Subject: PWR Owners Group, Risk Management Committee
PWR Owners Group Comments on [NRC-2021-0089], “Integrated Human Event Analysis System for Event and Condition Assessment Method and Software Tool”

Subject: **Documentation of Comments Pertaining to IDHEAS-ECA**

The following comments apply to draft for public comment of RIL-2020-02, *Integrated Human Event Analysis System for Event and Condition Assessment (IDHEAS-ECA.)*

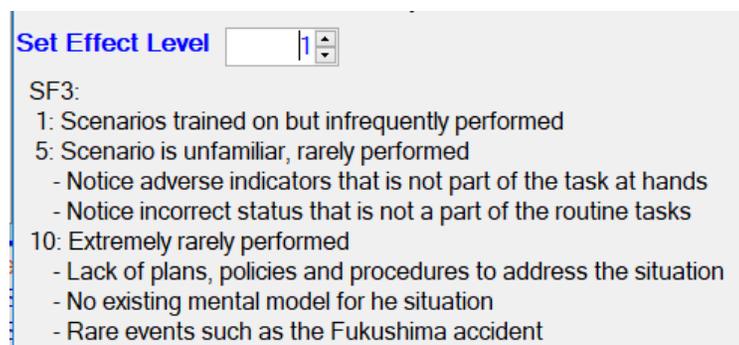
12. Some of the PIF attributes have Effect Levels. The value selected can have a major impact upon the HEP, but the guidance for selecting a value is ambiguous. For example, in SF3 shown below is there a basis for selecting values between 1 and 5, or between 5 and 10? What is the meaning of “adverse indicators that is not part of the task at hands?” Would FLEX HFEs always be a 10 since FLEX was created for events like Fukushima, regardless of whether training and procedures exist?
